7.0 Transport

Revised planning application - Lower basement level -2 showing extent of structural constraint to increase core size

Revised planning application - Ground floor plan and cross section. Bike route shown in red.

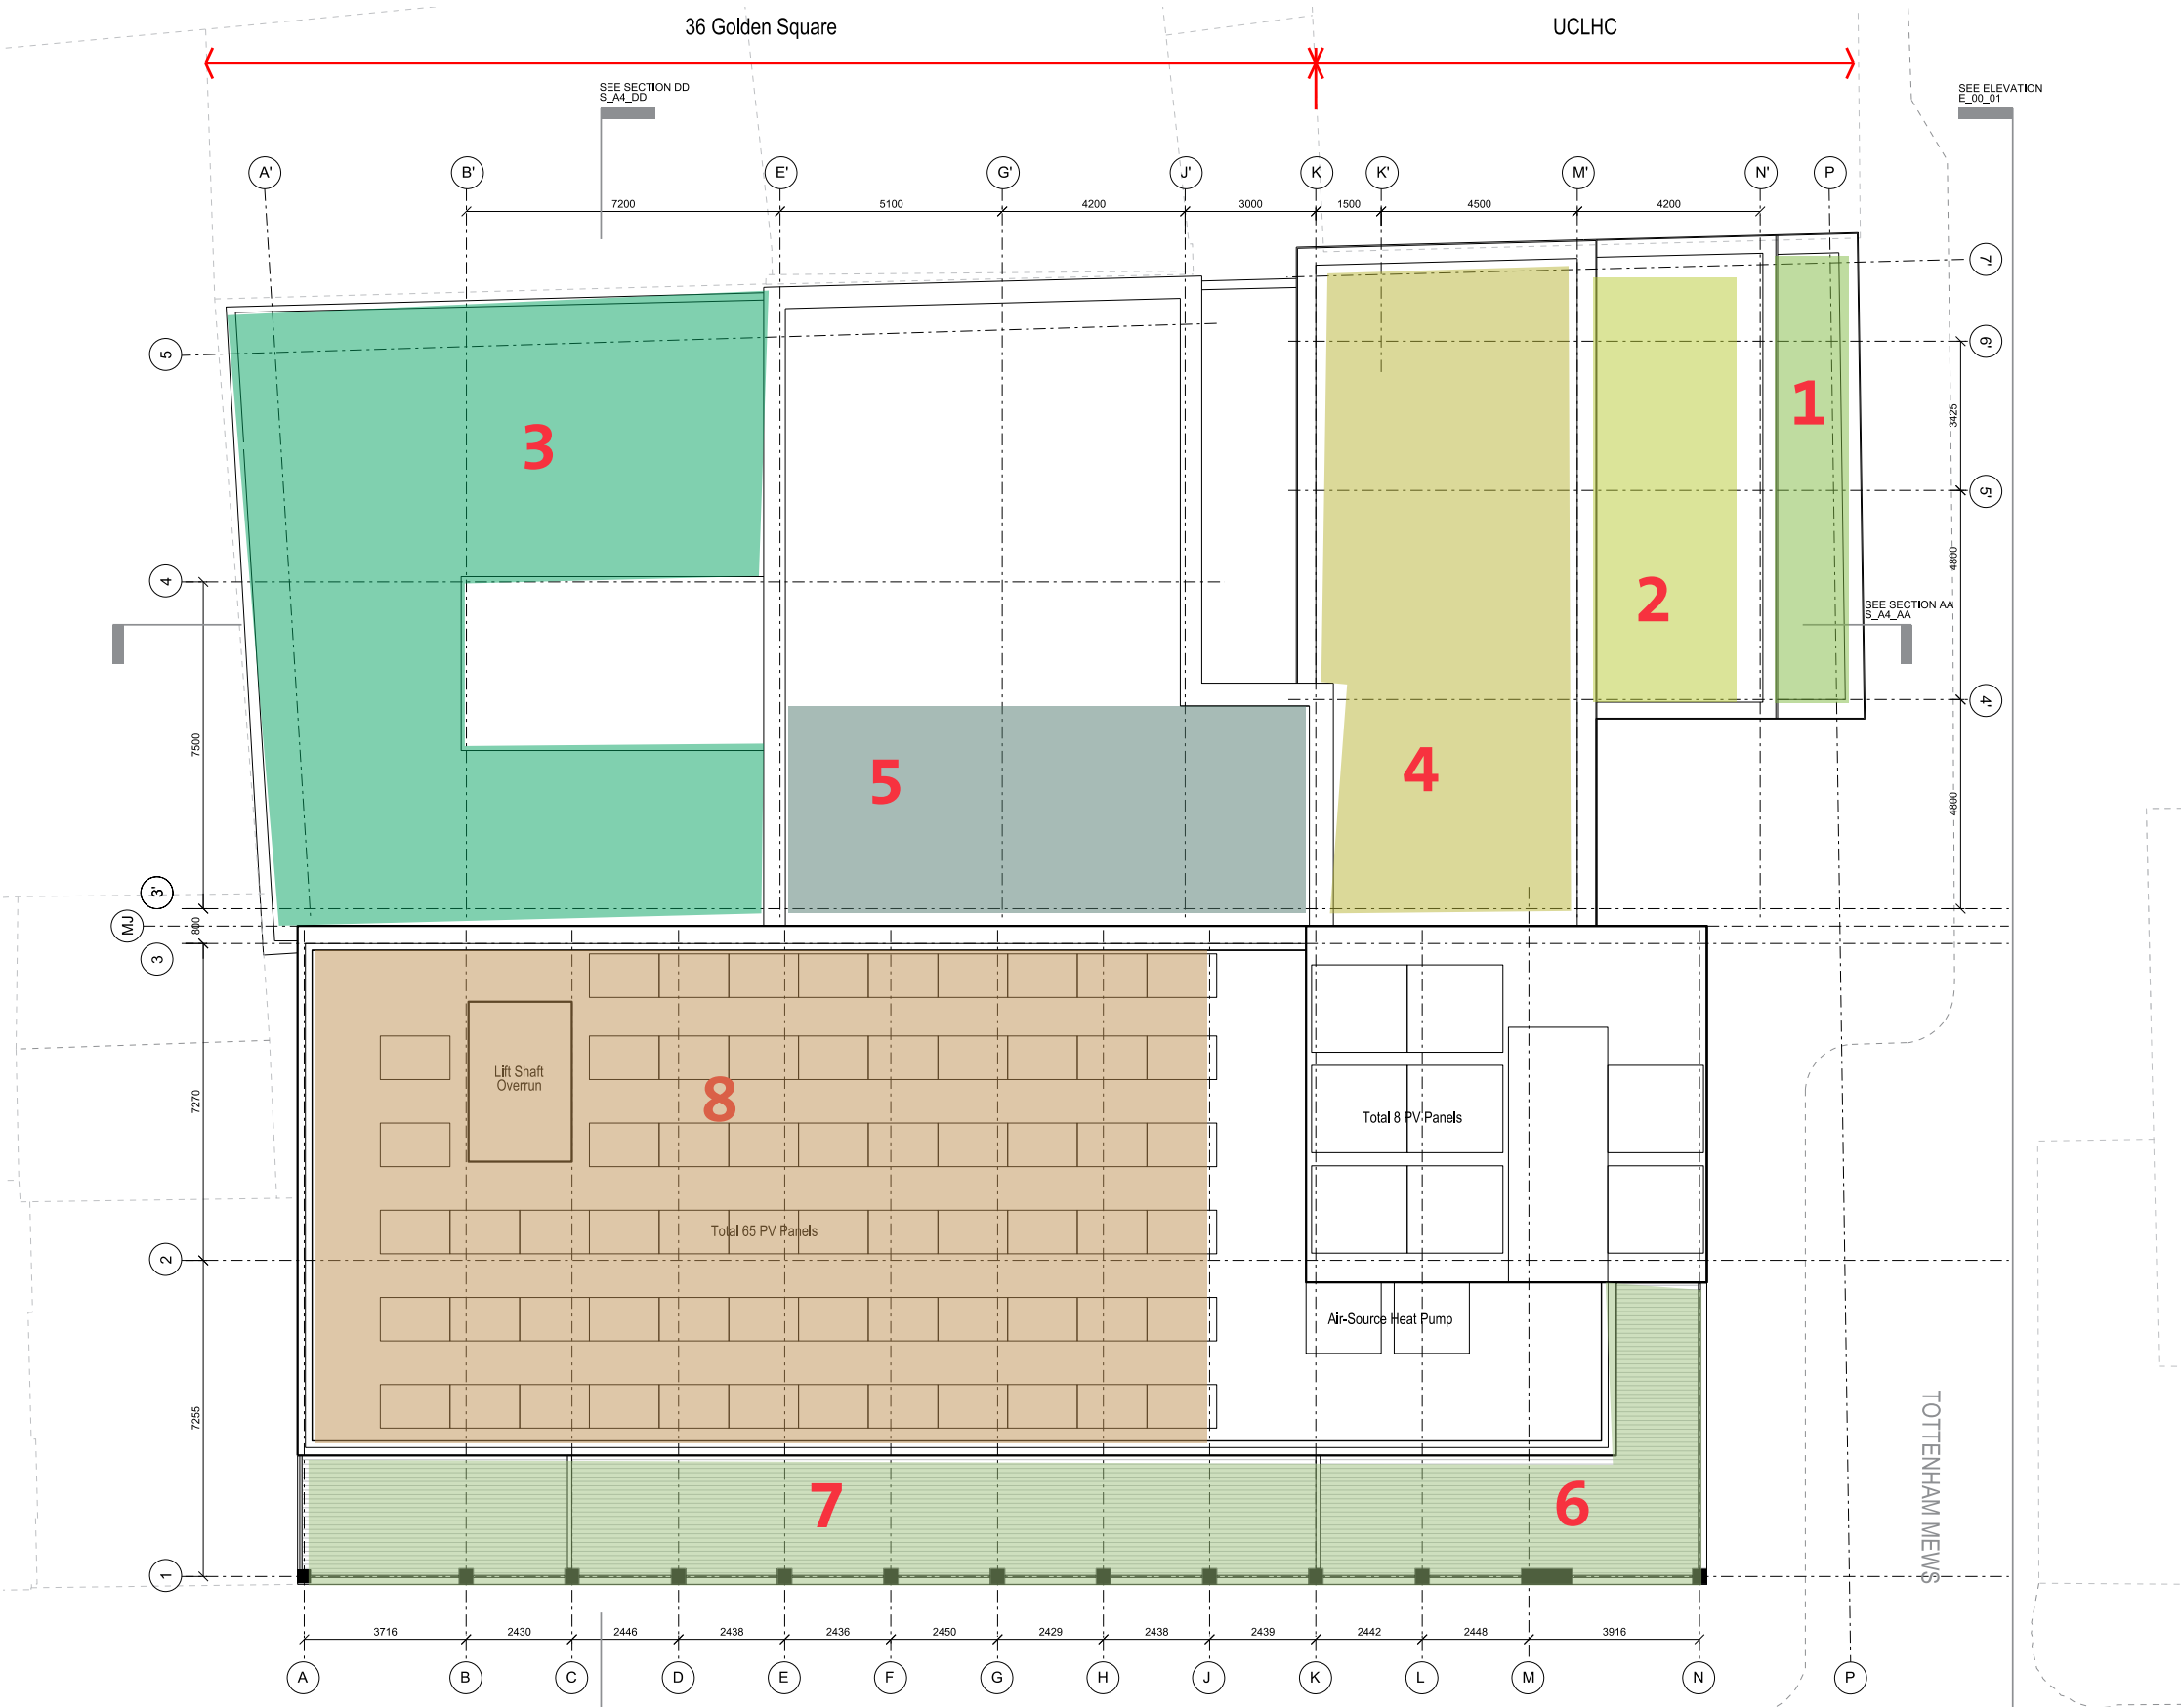
8.4.1 *ASHPs and PV are proposed to both the residential and non-residential elements of the scheme. Combined, these technologies will reduce emissions by approximately 9%, falling short of CPG 3 requirement for a 20% reduction.*

8.4.2 Team comments - As outlined in the sustainability assessment, many different renewable energy technologies have been evaluated. Based on our assessment the development is not suitable for ground source heat pumps, biomass heating, wind turbines, or a combined heat and power system. PVs were found to be more suited to the building requirements than solar thermal hot water, and have been implemented to the full extent possible. ASHPs have also been used where feasible as an alternative to ground source heat pumps.

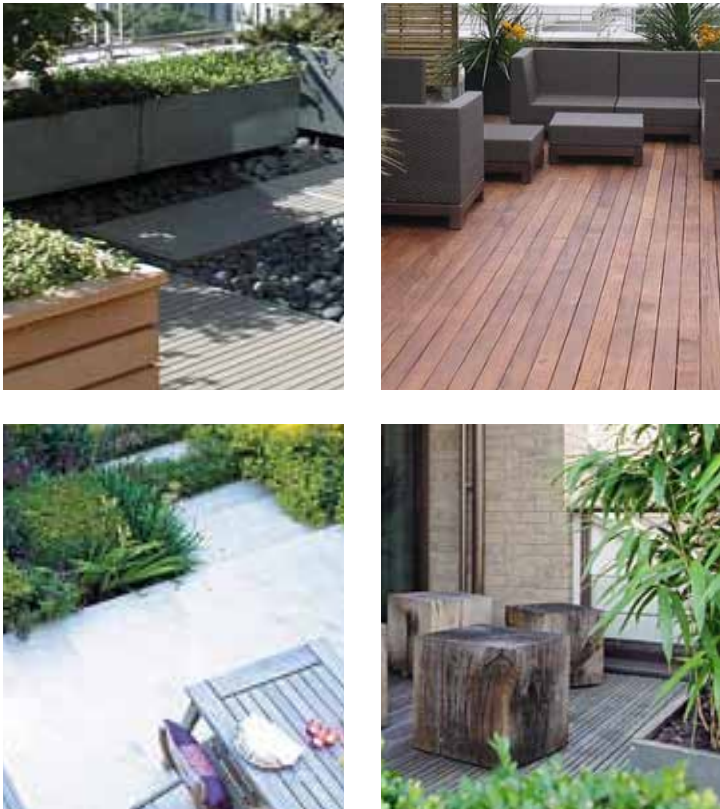
9.4.1 Green roofs - Section 8 of the design and access statement indicates green/ brown roof proposals for areas 5 and 8 below. However, this is not detailed on the drawings.

Residential - Communal Roof terrace (area 4). The rooftop garden will be accessible to all residents within the development. The communal roof garden would incorporate social seating areas nestled within a seasonally rich semi-extensive green roof planting. In addition there would be raised planters with generous soil depths. Shrubs and grasses would be planted for their tolerance of exposed conditions including the pink plumes of *Tamarix tetrandra* and arching golden spires of *Thamnochortus insignis* proving plenty of movement and visual interest.
